In support of comments #8, 9, 10, 11 against D1.2

David Lewis, Lumentum

IEEE P802.3cw 400 Gb/s over DWDM systems Task Force

Figure 155-2—Functional block diagram

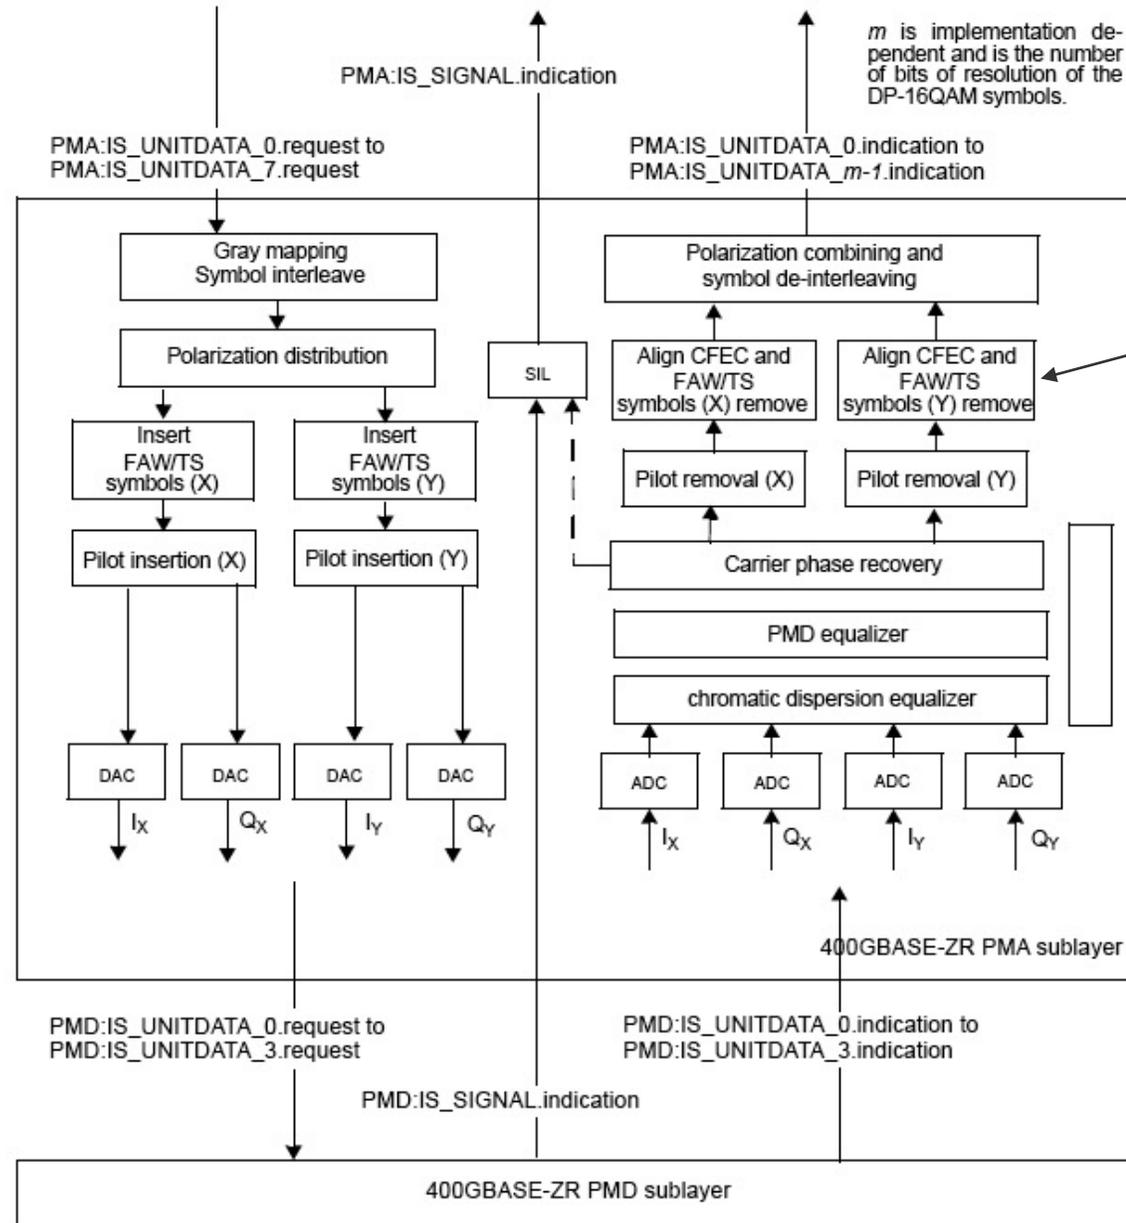
Comment #8: Need detailed functions and state machines at 155.4

PCS block diagram

Transmit state diagram from Fig 119-14

Receive state diagram from Fig 119-15

AM synchronization state diagram (new)

PMA block diagram

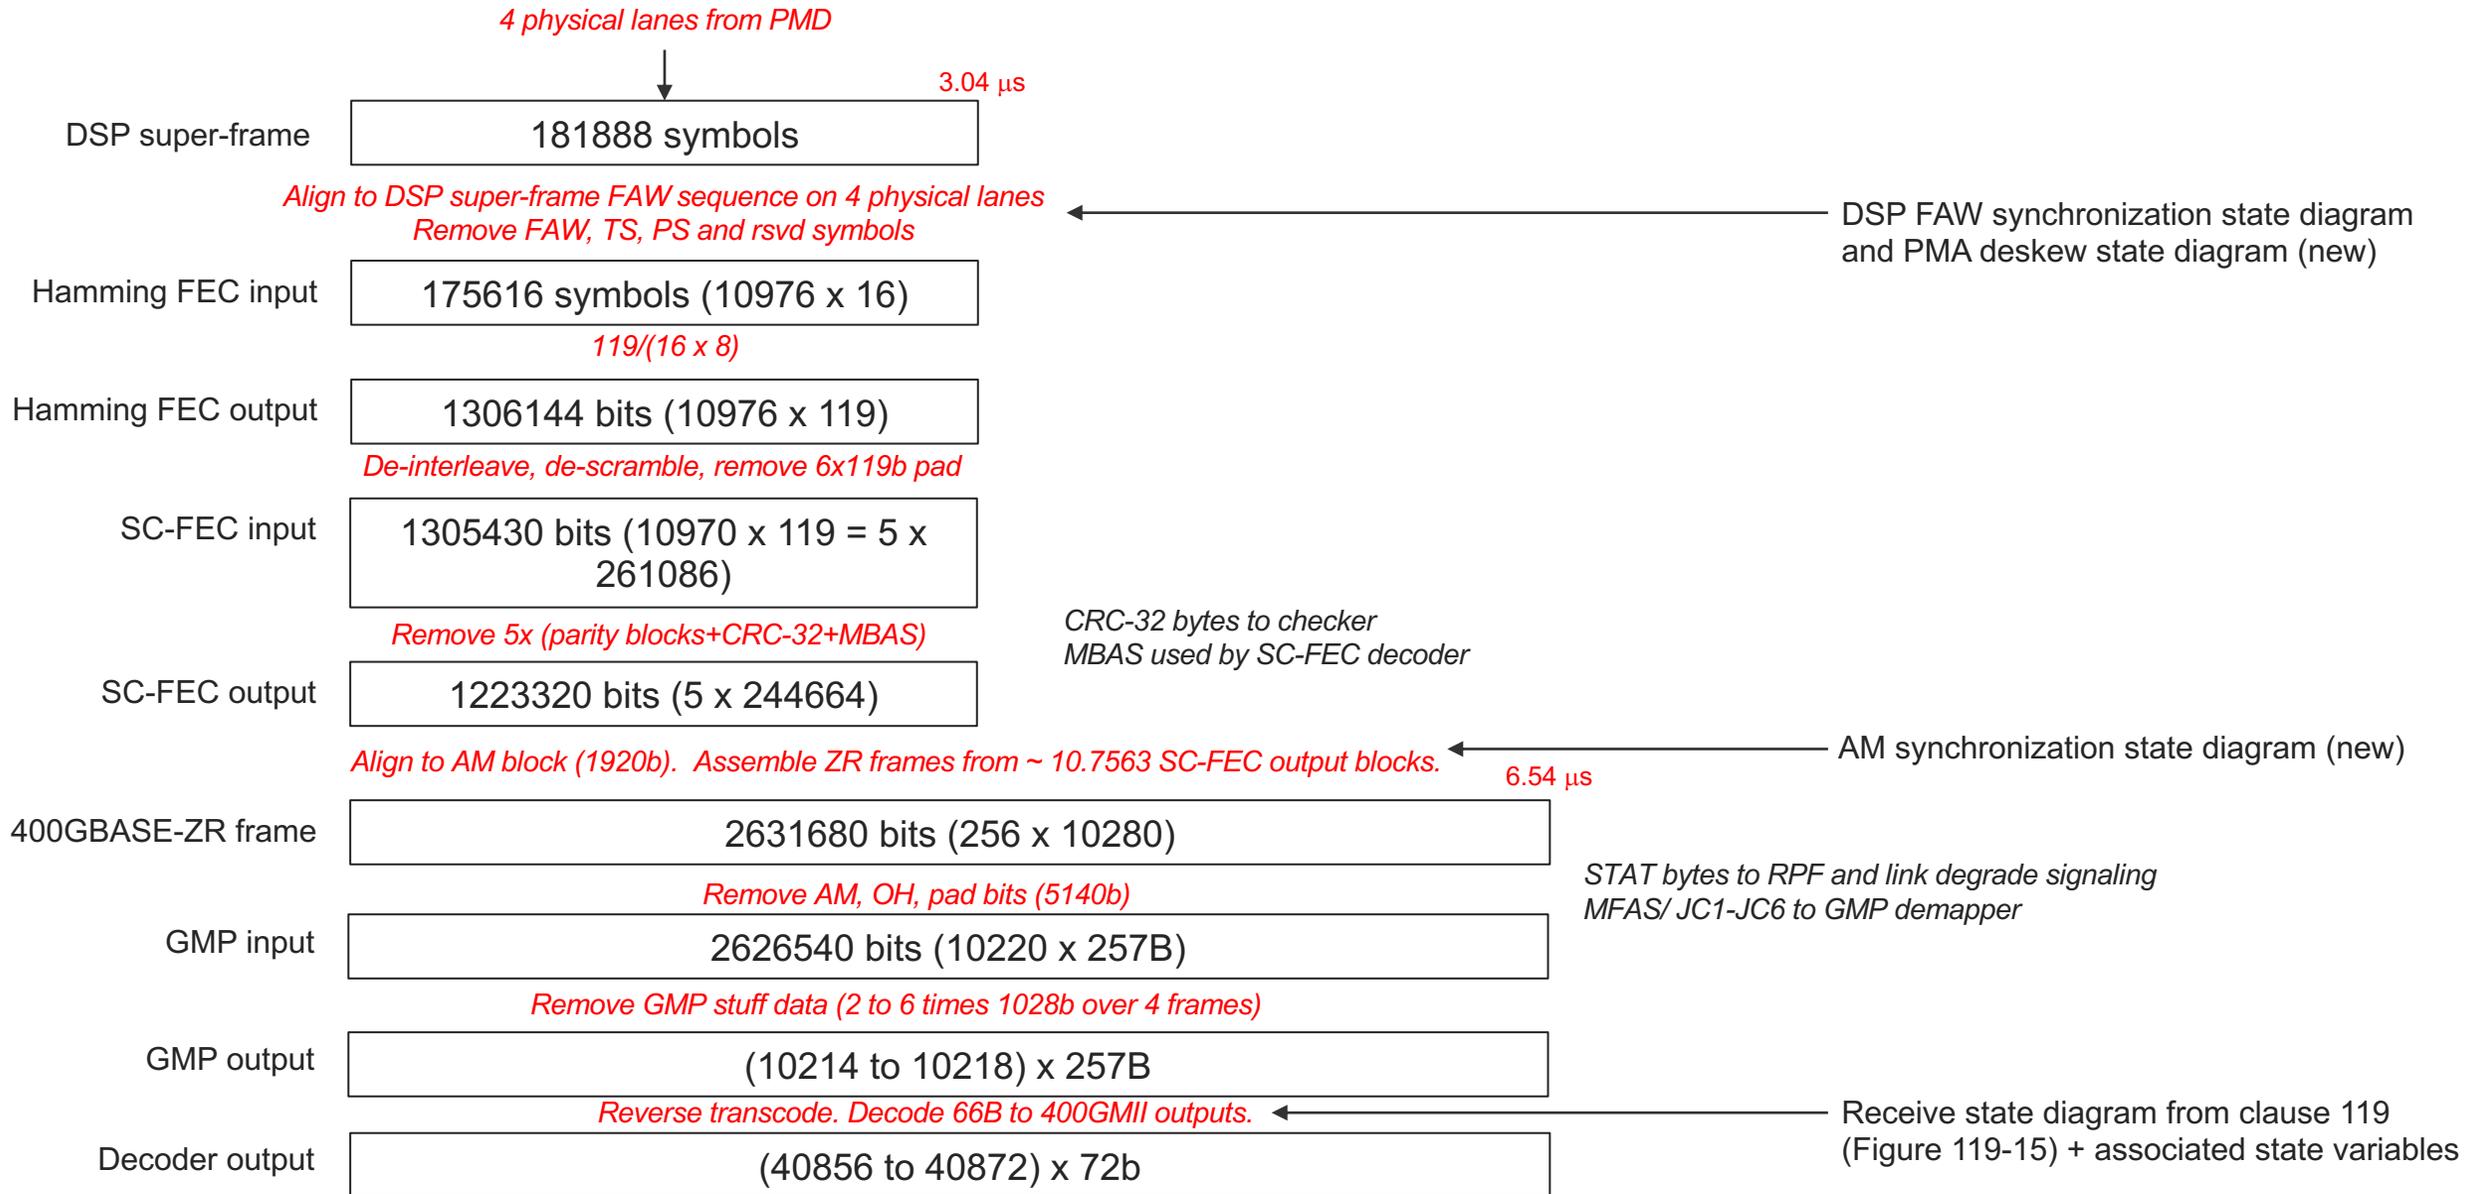
DSP FAW synchronization state diagram and PMA deskew state diagram (new)

Where are new state diagrams needed? PCS receive direction

Figure 155-13—DSP FAW synchronization state diagram

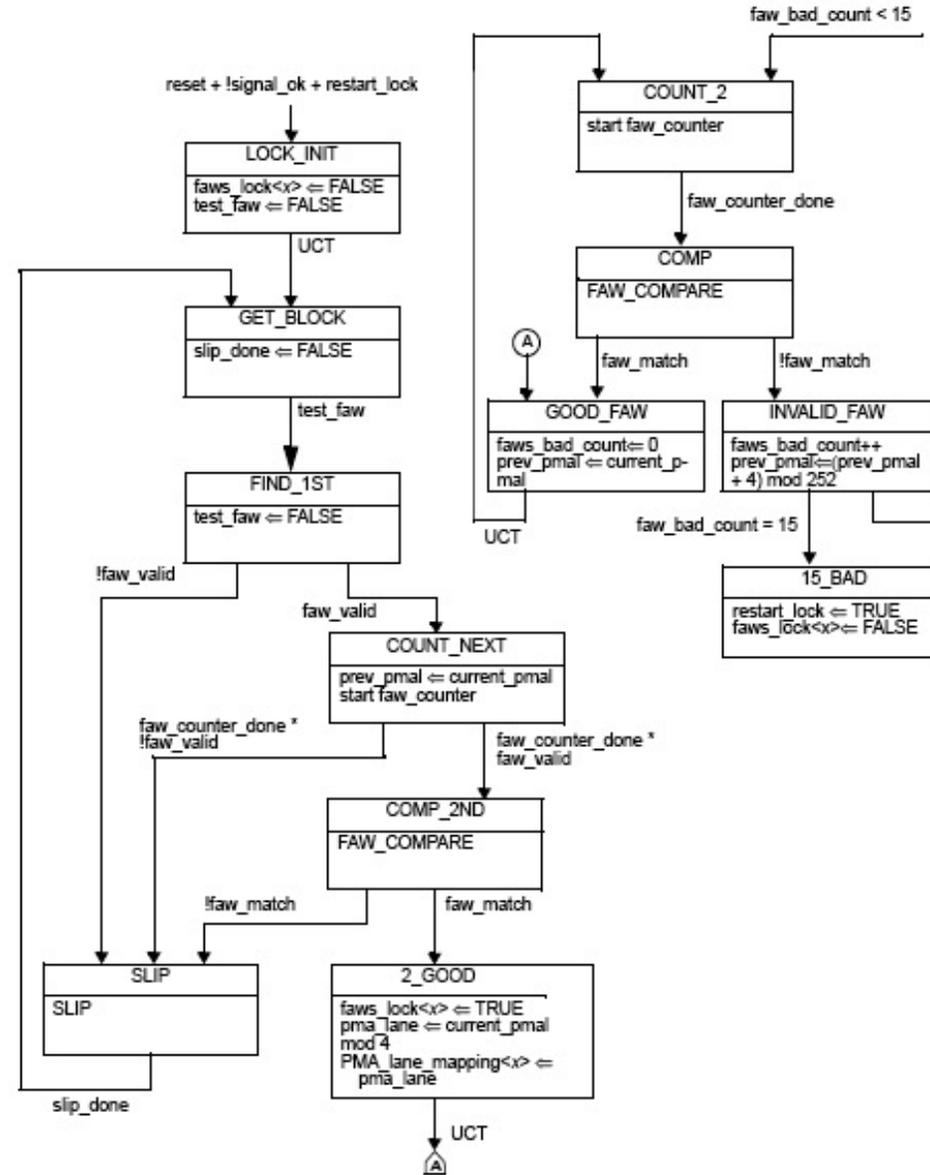
DSP FAW lock state diagram

- Based on 802.3ct Figure 153-7 with fas replaced by faw, and fec1 replaced by pma1
- 4 lanes instead of 20

The PMA shall implement 4 DSP FAW synchronization processes as shown in Figure 155-13 to identify the boundaries of DSP super-frames by observing the stream of symbols on four physical lanes. The synchronization process operates independently on each lane. The synchronization state diagram determines when the PMA has detected the location of the frame alignment word sequence in the received symbol stream for a given lane of the PMA service interface.

Figure 155-14—PMA deskew state diagram

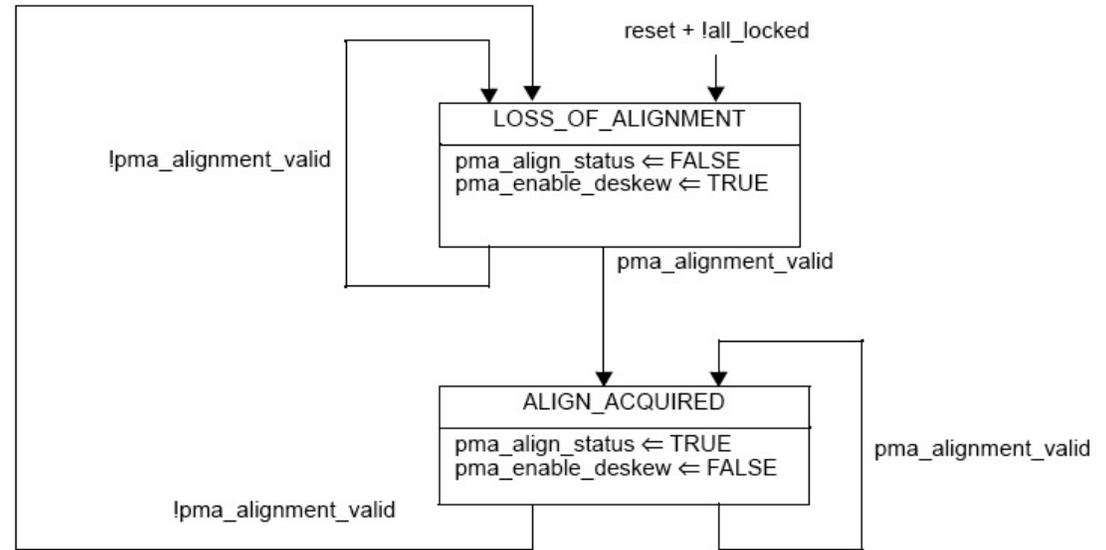
PMA deskew state diagram

- Based on 802.3ct Figure 153-8 with fec_align replaced by pma_align

The PMA shall also implement the deskew process as shown in Figure 155-14.

Figure 155-15—Alignment marker lock state diagram

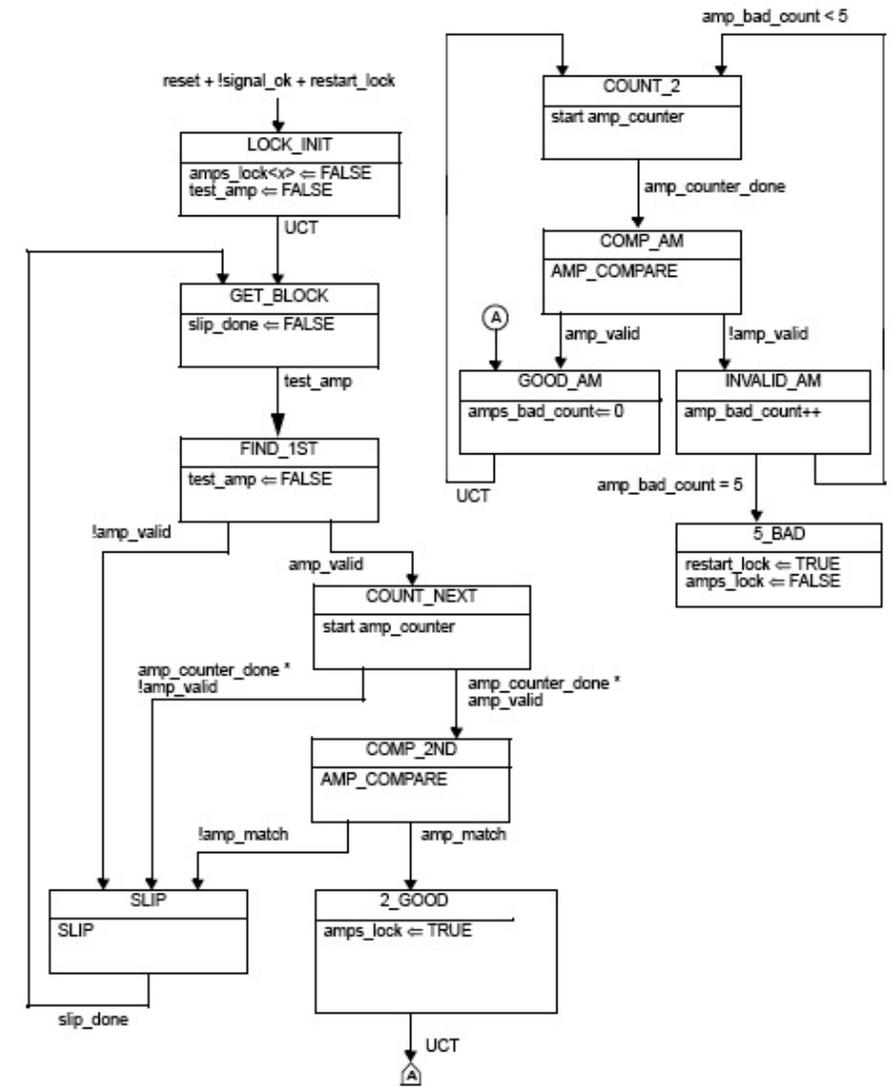
Alignment marker lock state diagram

- Based on Figure 119-12 (400GBASE-R PCS) but for a single lane
- No need for lane mapping
- Look for all 1920 bits (16x120) instead of just a single 120-bit sequence?

The PCS shall implement the alignment marker lock process as shown in Figure 155-15 to identify the AM sequence at the start of each 400GBASE-ZR frame by observing data from the SC-FEC decoder output.
